**.HISTORIC LANDMARK COMMISSION
STAFF REPORT**

Roof Alteration,
Ellerback House Minor Alteration &
PLNHLC2008-00528
210 North State Street
December 3, 2008

Request

Attachment A
Site Plan and Elevation Drawings

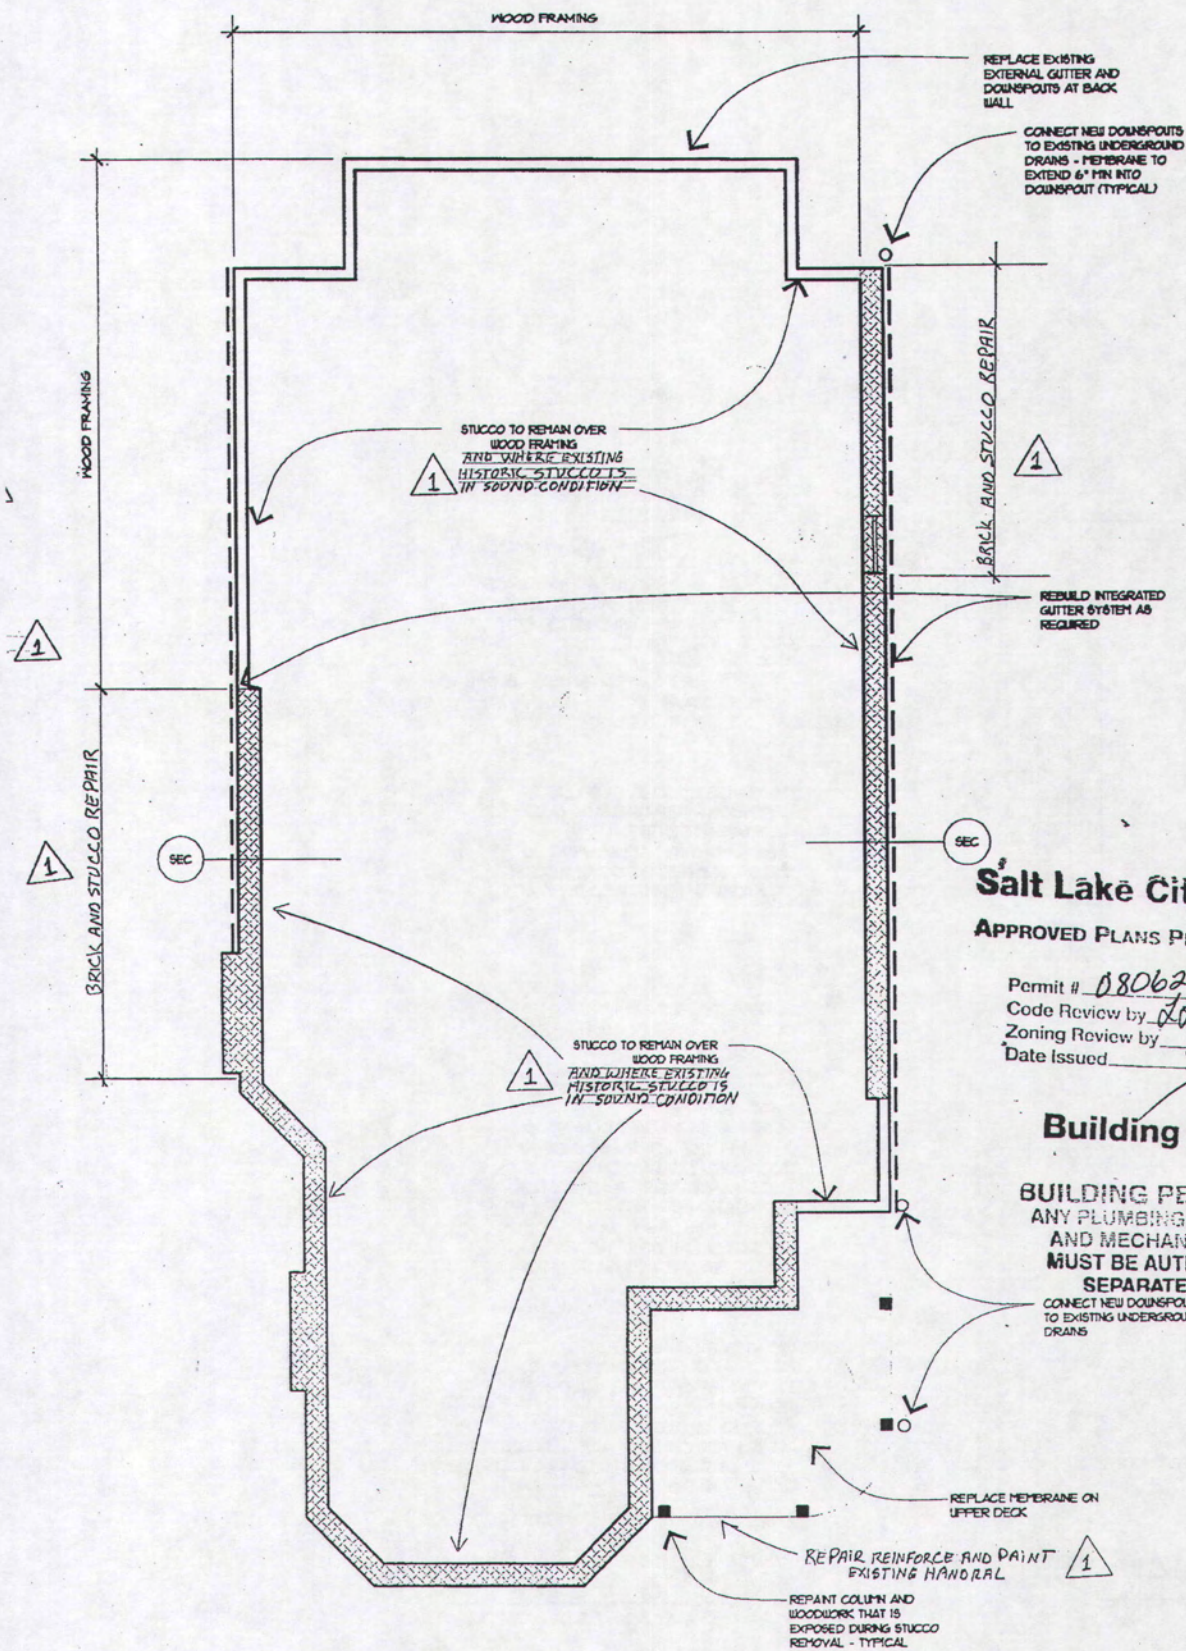
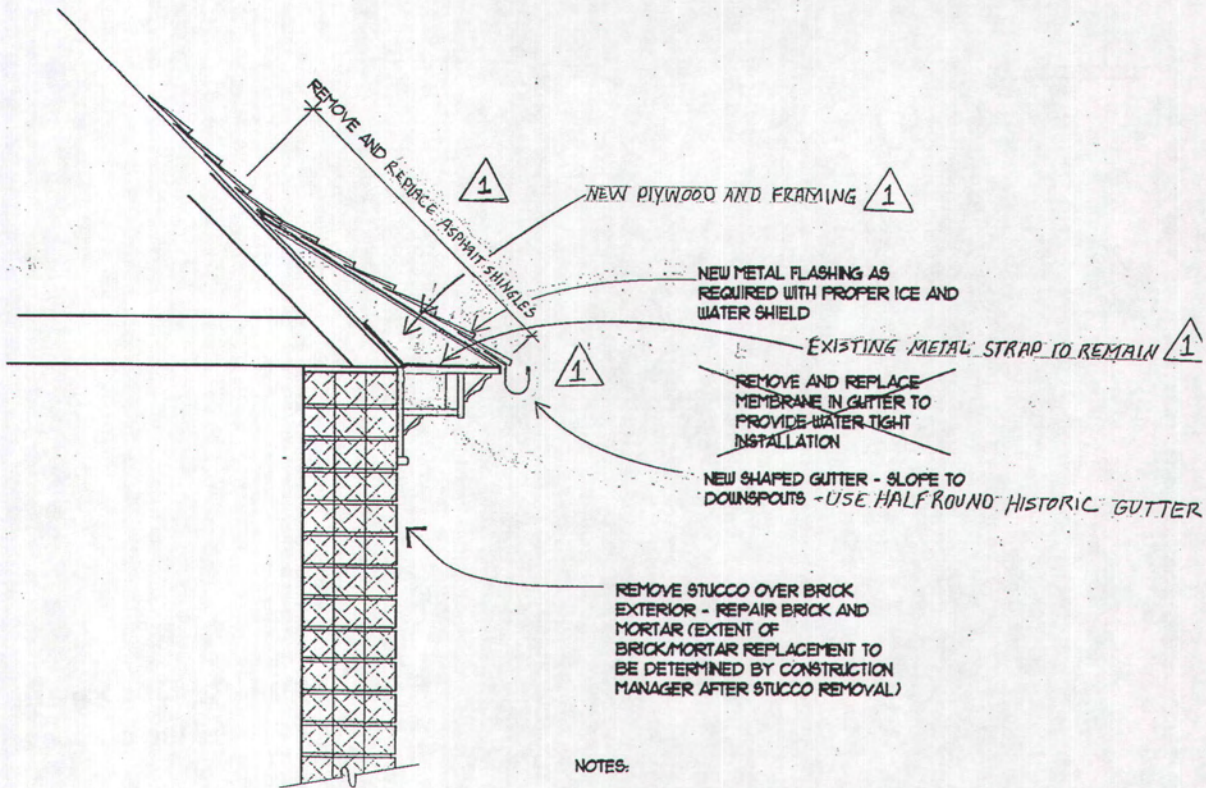
The roof angle alteration proposed does not substantially meet this standard since it will change a distinctive feature of the building, the roofline. The design guidelines further clarify that altering the angle of a roofline should be avoided.

The hidden gutters are a feature of the house that should be repaired rather than replaced. However, if the Historic Landmark Commission finds that repair of these gutters is not feasible, than the proposed new gutters appear to meet the requirements outlined in the design guidelines. They do not match the gutters they are replacing in anyway but a half-round gutter is an appropriate external style gutter for a house of this age and style.

The addition to the roofline does not meet this standard since it cannot be easily removed and further damage to the existing gutters may take place with the installation of the new roofline.

1. Approve the repair of brick and stucco;
2. Approve the replacement of the roofing material for the porch;
3. Deny the change to the roofline; and
4. Require the repair of the existing hidden gutters with the addition of external downspouts.

210 N STATB- EVIDENCE OF DAMAGE- INTERNAL GUT

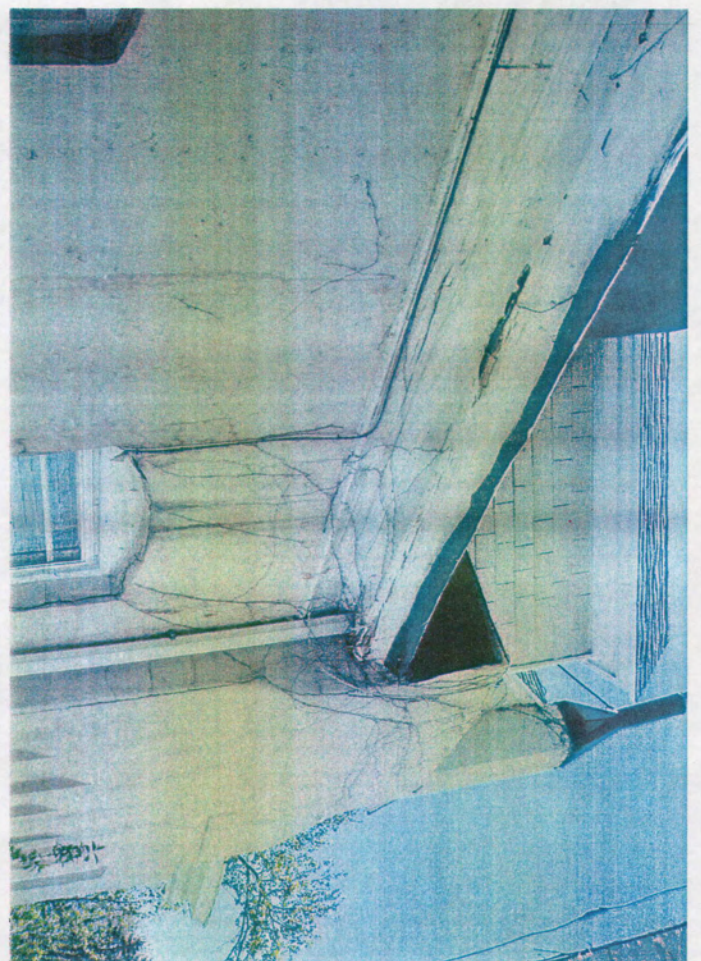
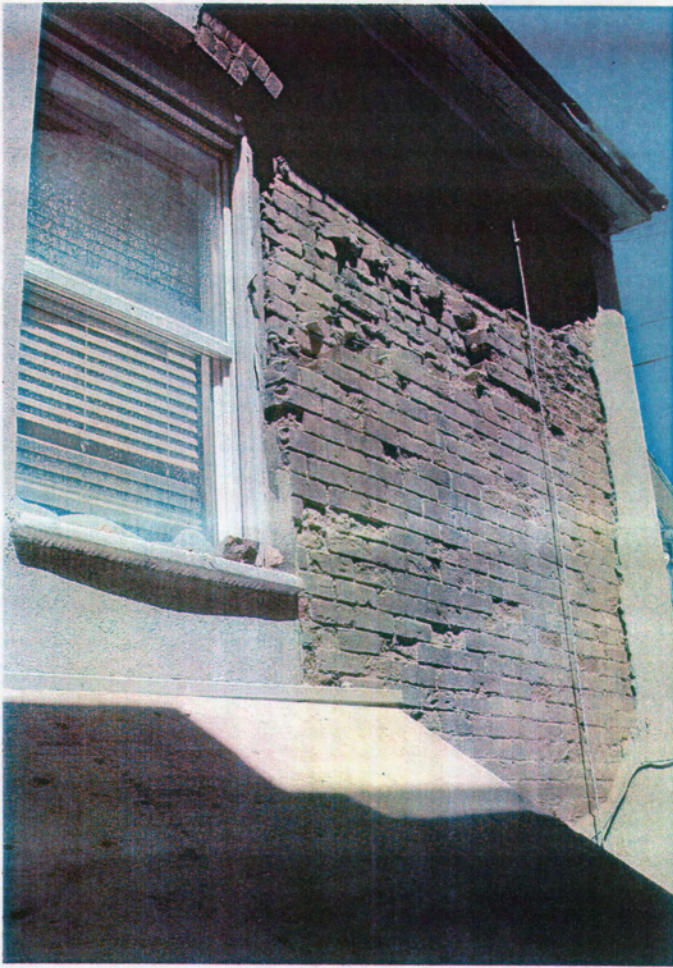
1. The problem is water penetration into the brick and stucco. The source of the water is the internal gutter system. The result of the problem is destroyed brick and stucco around a significant portion of the exterior of the home.
2. The recommendation is to cover the top of the internal gutter with a new roof as an extension of the bottom 3 feet of the existing roof and install a historically appropriate half round external gutter.

HOME TO THE NORTH

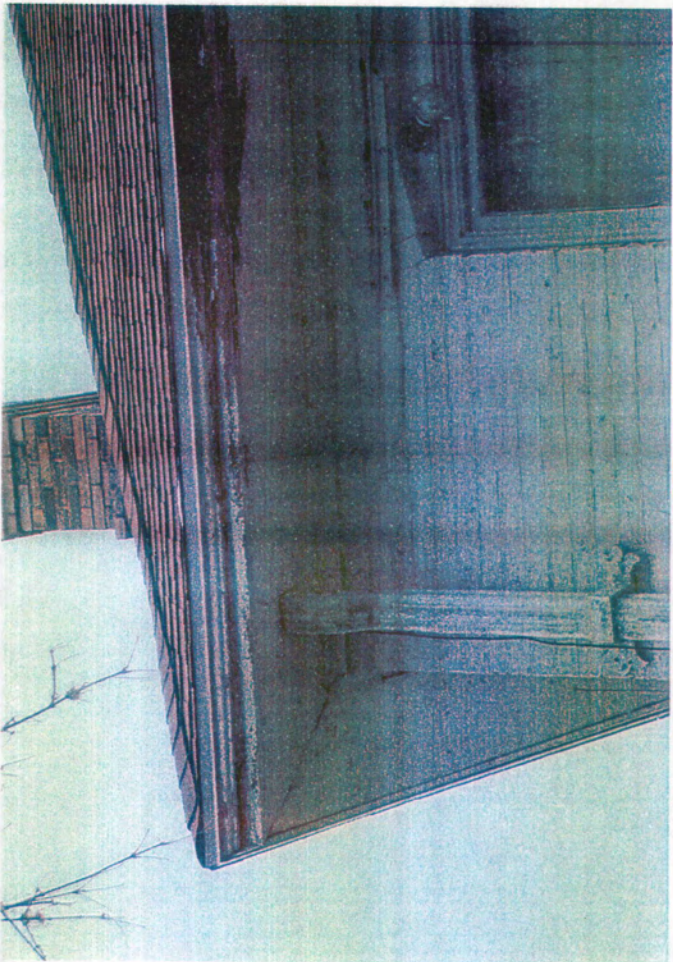
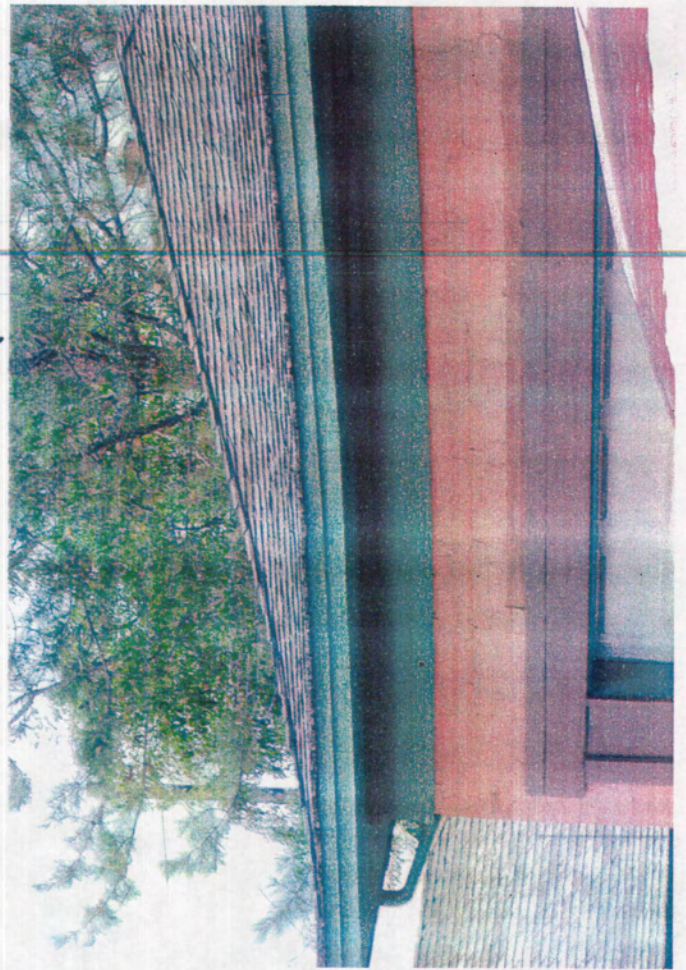
2. As far as the appropriateness for this application in the historic district, we point to the home to the immediate north. It's apparent that they experienced such extensive problems with the internal gutters that the entire soffit, fascia and internal gutter system was removed. Currently there are no gutters on the home. Evidence of the previous internal gutter system is an original downspout that was not removed and which no longer serves a purpose.
